COMMITTEE REPORT

BY THE EXECUTIVE DIRECTOR OF ECONOMIC GROWTH & NEIGHBOURHOOD SERVICES
READING BOROUGH COUNCIL
PLANNING APPLICATIONS COMMITTEE: 30th March 2022

App No.: 211127

Proposal: Complete redevelopment of Ranikhet Academy Primary School, comprising construction of a new two form entry, two storey school building, new Multi Use Games Area, Car Parking, playground areas and other landscaped features along with the demolitions of all existing school buildings

Figure 2 – Spey Road / Eddleston Way Junction Desire Line Crossing.

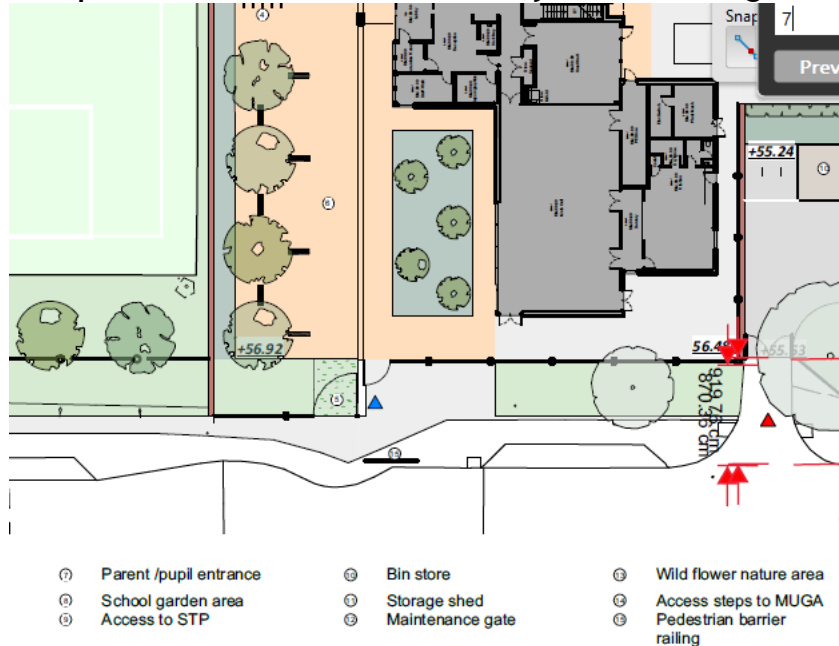
However, a new pedestrian entrance (access gate) is to be relocated closer to the junction of Spey Road/Eddleston Way, along the eastern boundary to serve the new semi public entrance zones. Therefore, pedestrian desire lines are likely to change as a result of the new position of the entrance. Pedestrians approaching from the west of the estate along the southern footway on Spey Road are more likely to cross diagonally on the bend for a direct route into the school entrance. As the walking audit suggests, this junction is where buses turn though the estate and there is a restricted field of vision due to the 90 degree bend and on-street parking bays. Therefore, I am concerned that the proposed location of the new pedestrian entrance will encourage pedestrians to cross Spey Road in potentially dangerous location without any formal crossing facilities.

Further, the applicant was requested at pre-application stage to identify a location for a formal crossing point within the audit and include drawings of potential options. However, it does not appear that any preliminary drawings have been submitted for review as referenced in paragraph 2.2.9 of Transport Statement.

A new pedestrian entrance (access gate) is to be relocated closer to the junction of Spey Road/Eddeston Way, along the eastern boundary to serve the new semi public entrance zones. Therefore, pedestrian desire lines are likely to change as a result of the new position of the entrance. The applicant has confirmed that a new pedestrian gate will limit access to fewer pedestrians entering here, as it will be for Visitors, Nursery and Reception years only at this point. The other years (1-6) will not be able to physically access their areas from this new entrance, they will use the new entrance on the north/east boundary.

Furthermore, as part of the School Travel Plan, a school travel survey was circulated to parents at the school. No concerns were raised by parents that specifically mentioned crossing Spey Road within the survey. Postcode plots of where pupils are travelling from (home) to the school were obtained as part of the School Travel Plan which identified that the vast majority of pupils live to the east and north of the school site. Given that years (1-6) will not be able to physically access their areas from the Spey Road entrance, the main pedestrian entrances into the school for pupils in Y1 to Y6 are located on the north/east boundary. Therefore, the applicant determines that it is unlikely that a crossing in the proposed location would be widely used by pupils/parents given the postcode data and the new location of the pedestrian entrances.

Landscape General Arrangement Plan

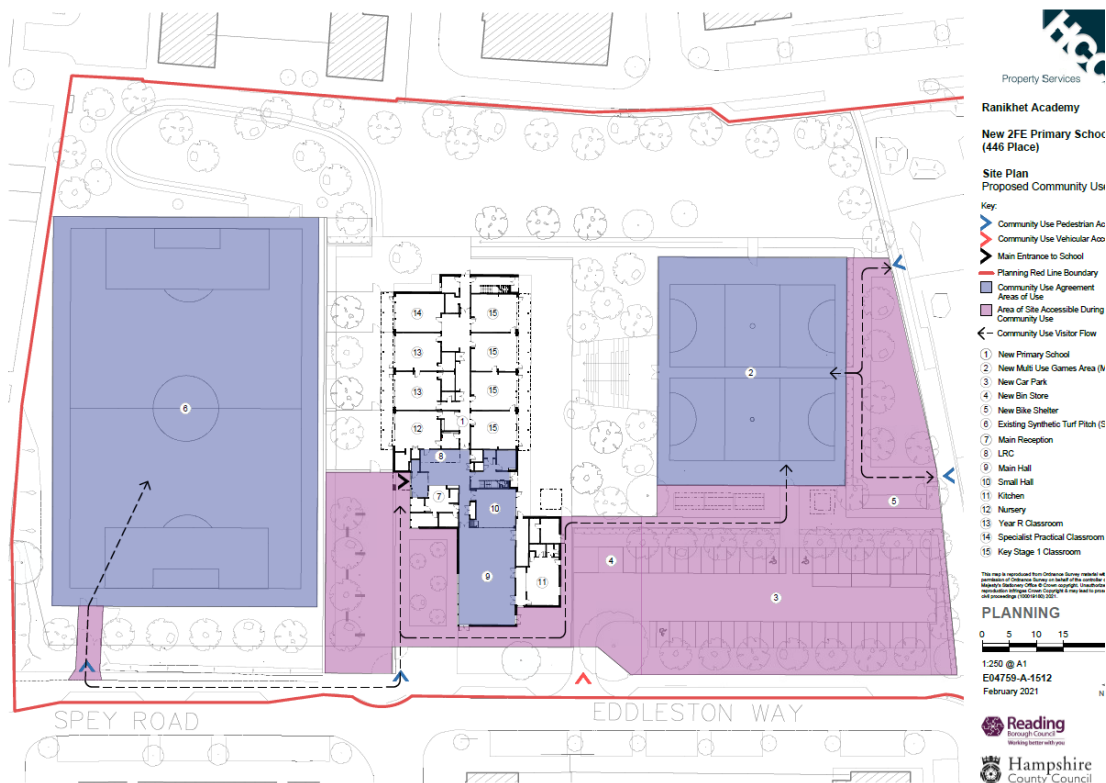
It is worth noting that the proposed layout allows for tree planting effectively all around the site boundary and also throughout the site, which is positive.

Section 3.4 of the AIA mentions that 'around 80' new trees are proposed for planting. The Landscape General Arrangement Plan shows 84 new trees to be planted. A planting schedule was not submitted to confirm either of these 2 numbers, but the scheme demonstrates landscaping principles to an acceptable degree. The planting schedule details can be secured via condition, although, as above, it is preferred that these are submitted prior to a decision.

- 4.4 **Officer Note:** Subsequent to this, discussions were held resulting in revised information being provided and the conclusion that the latest submitted documents demonstrate tree protection and landscaping in principle and the proposal could be supported in terms of natural environment. Any remaining matters can be suitably dealt with by condition. As such, the application is supported subject to conditions L2 (landscaping etc), L7 (submission of an AMS) and L3 (boundary treatment).
